**No. EC155-63A014**

## ALERT SERVICE BULLETIN

#### MAIN ROTOR DRIVE - Change of pressure switch of the dual pump MGB oil pressure

Corresponds to modification 0779B39

Figure 1 - Replacement of pressure switches "16E", "65E" and "66E"

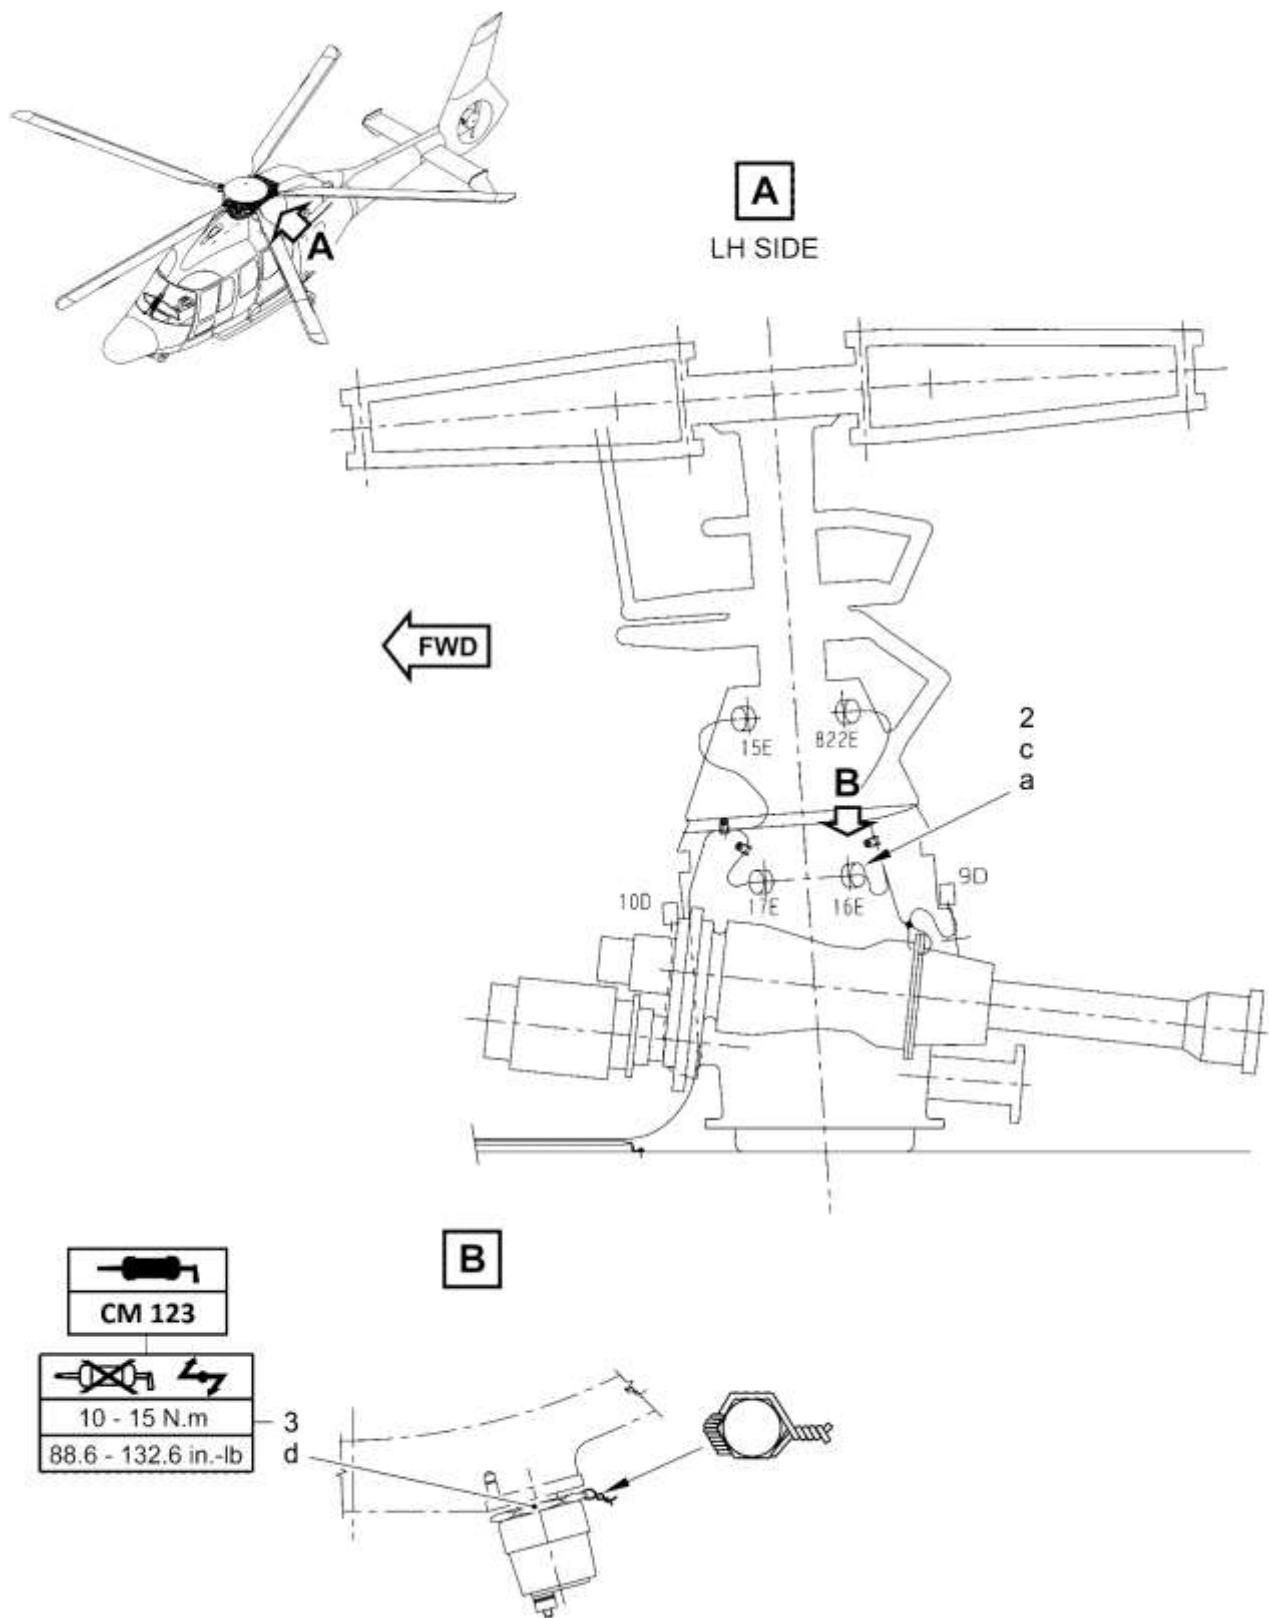
##### 3.B.2.a. Remove the old pressure switch "16E" (Figure 1)

- Disconnect the connector (a) "16E" (Detail A).
- Remove and discard the lockwires (Detail B).
- Remove and store the pressure switch (c) (Detail A).
- Discard the sealing bushes (d) (Detail B).

##### 3.B.2.b. Installation of the new pressure switch "16E" (Figure 1)

- Secure lockwire (1) to the pressure switch (2) (Detail A and B).

- Lubricate the sealing bushes (3) with oil (4).
- Install the pressure switch (2) with the sealing bush (3) (Details A and B).

- Tighten to the indicated torque (Detail B).
- Safety the pressure switch (2) to the sealing bush (3) using lockwire (1) (previously secured to the pressure switch (2)).
- Connect the connector (a) "16E" again (Details A and B).
